**Re: P-21-0034 | 06-171, East Town Crossing – Preliminary Site Plan Review and SEPA Response Letter**

The following are comments provided by the City of Puyallup from the DRT Letter dated 7/12/21, with our responses in **blue**.

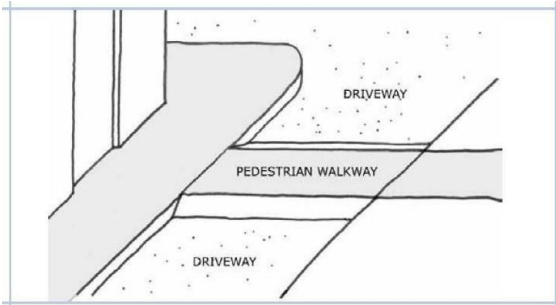
- Drive-through lanes shall only be placed parallel to a road if separated by a distance of 30 feet, or if fully screened by a 15-foot type IIb landscape setback with a designed landscape berm (six feet high at center of berm in 15-foot landscape setback) or three-and-one-half-foot decorative masonry wall.

**The proposed drive-thru is parallel to the road and setback +20ft from the road.**

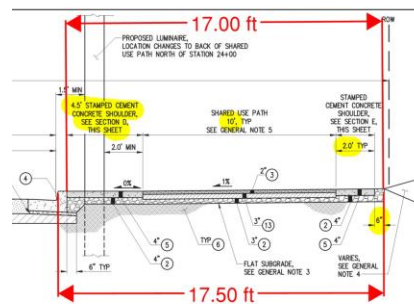
54. Confirm proposed ROW dedication along Shaw Rd will accommodate shared use path dimensions (17.5ft from face of curb). See exhibit below:
